TOWN OF WELLINGTON PLANNING COMMISSION June 2, 2025 6:30 PM

Final Plat for Wellington Business Center, Lots 7 & 8

Subject: Review of Amended Site Development Plans for Lots 1 and 2, Block 2, Bonfire Subdivision

Amended Site Development Plan for Kaufman & Robinson Inc.

25007 4/21/2025 4:35:42 PM

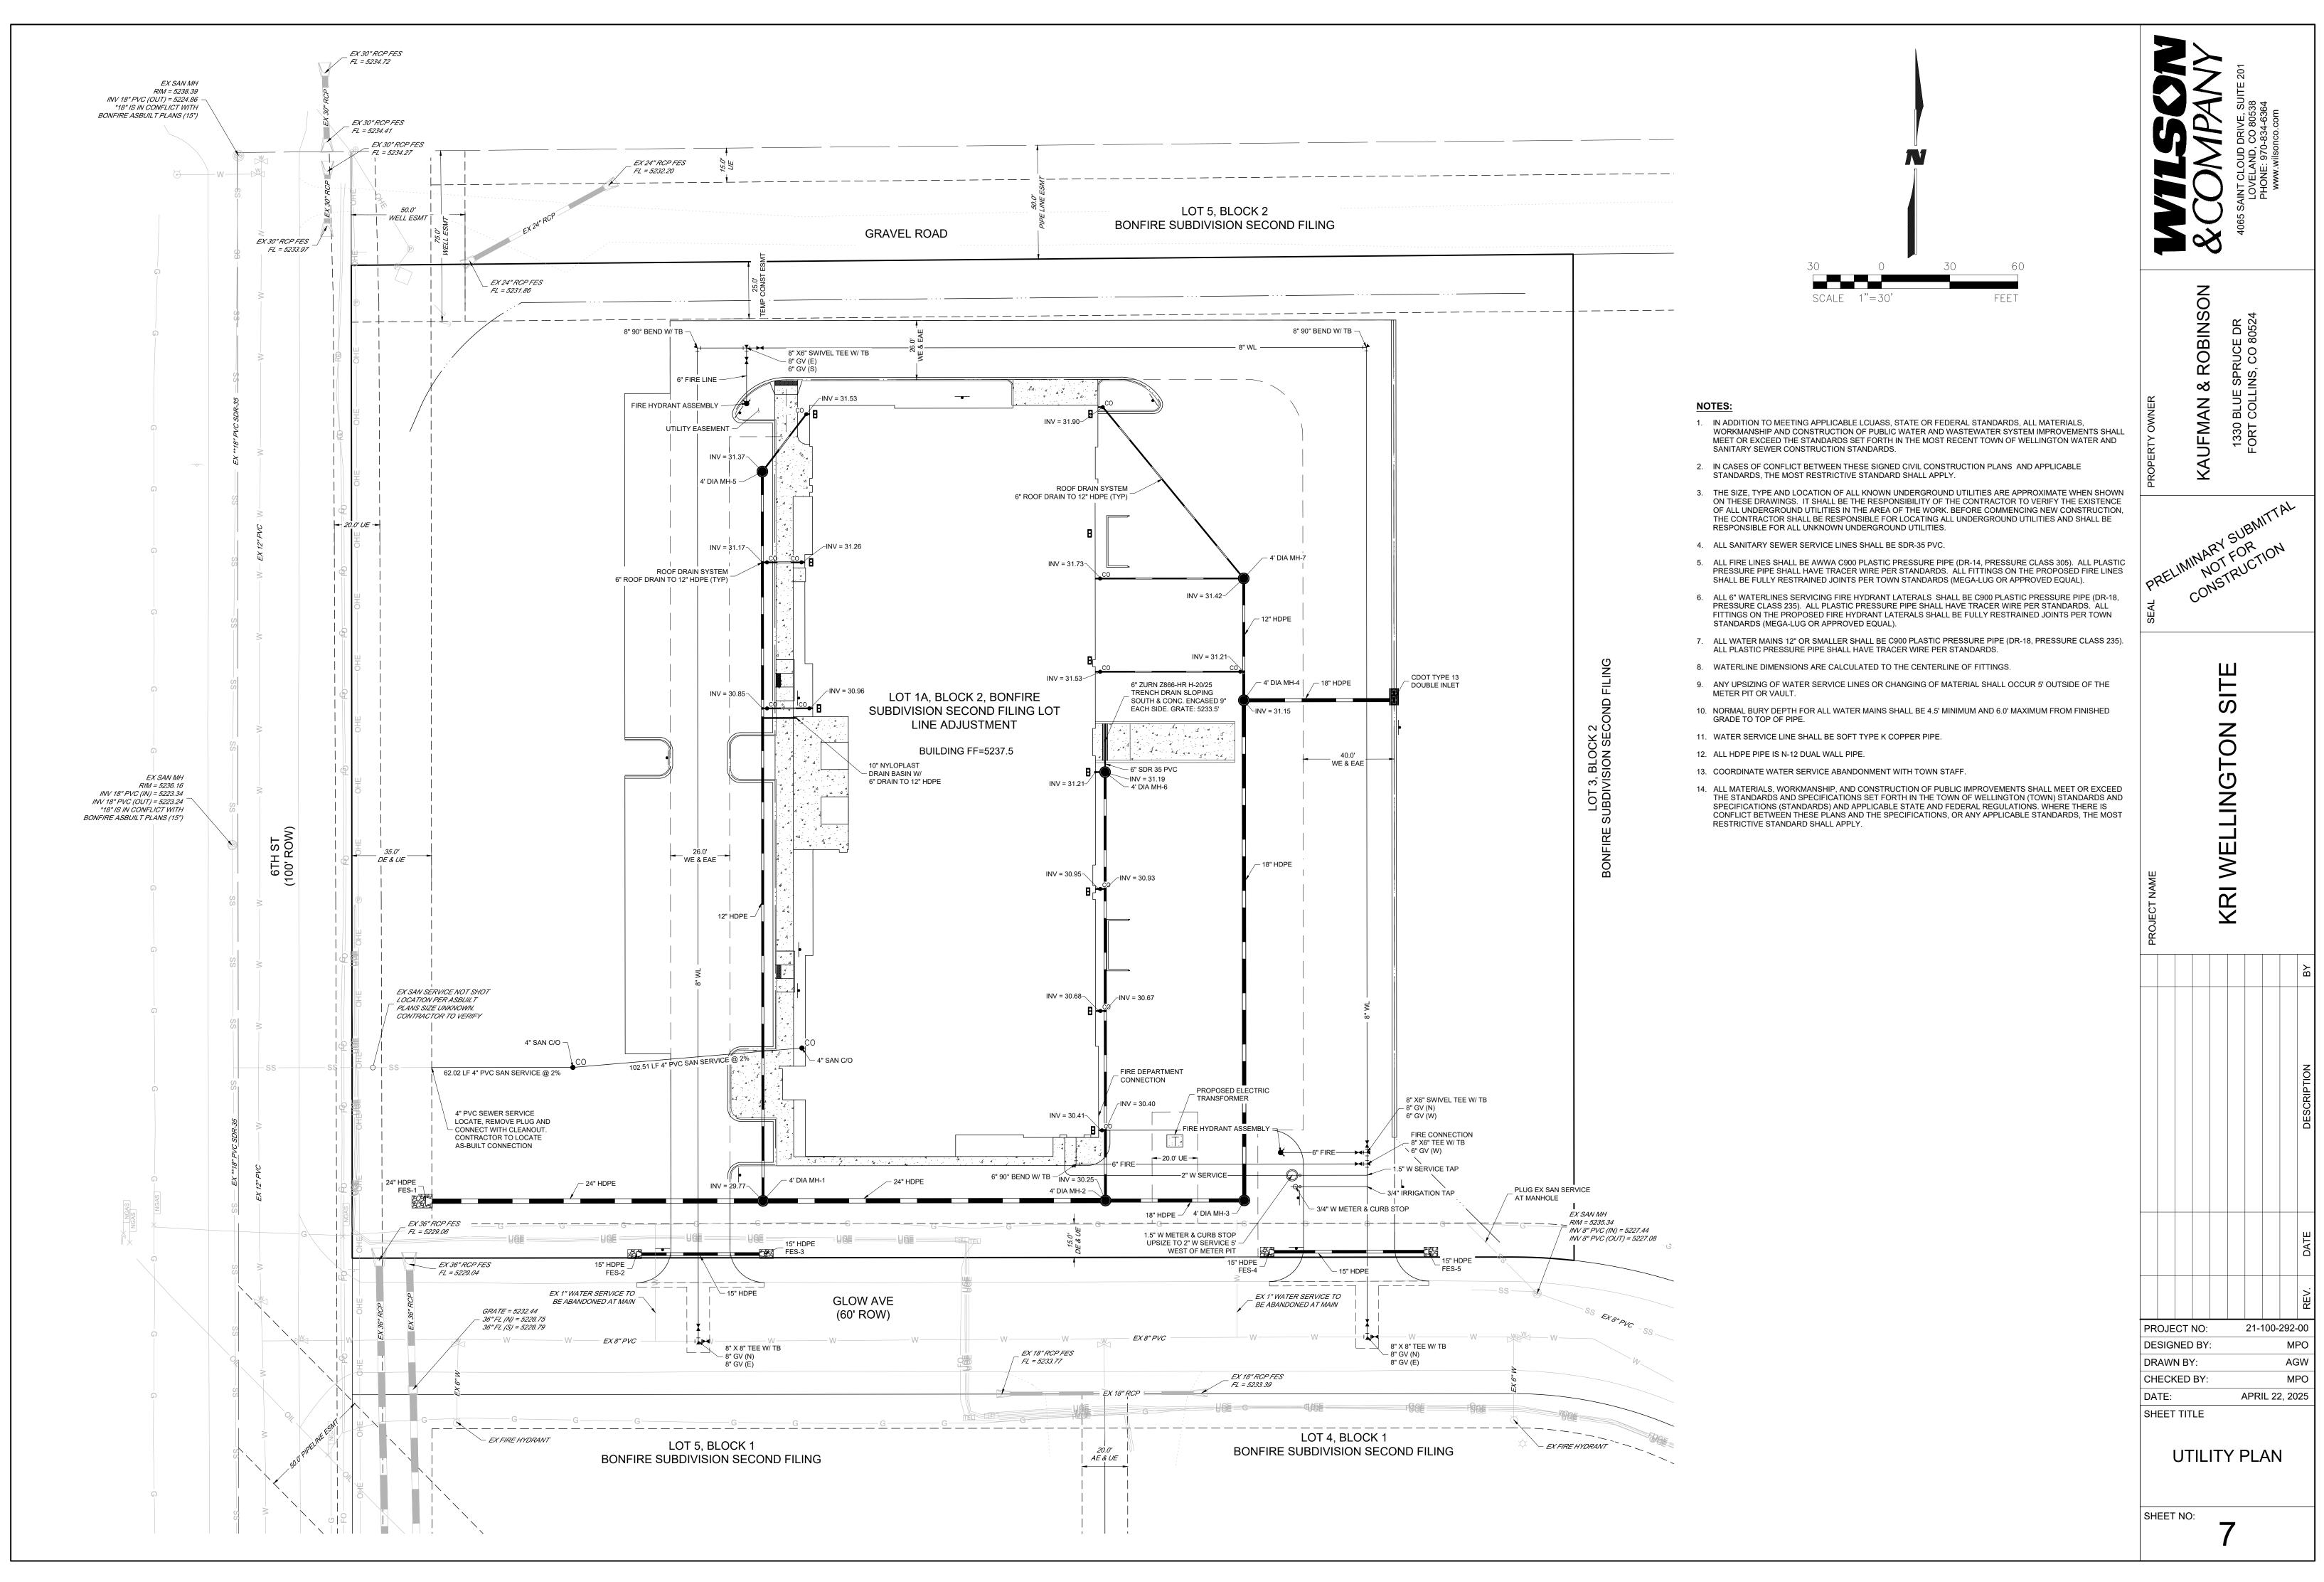
- The applicant is proposing to increase the building height from 28 ft. for the prior approval to 37 ft. The height increase exceeds 10% that can be approved administratively, and requires review by the Planning Commission.

- o The height of the building was increased to 37 feet. It is less than the district maximum of 45 feet.
- There were minor changes to the building layout (orientation and location of doors, a slight change to the building footprint). The building itself is not proposed to change in size.
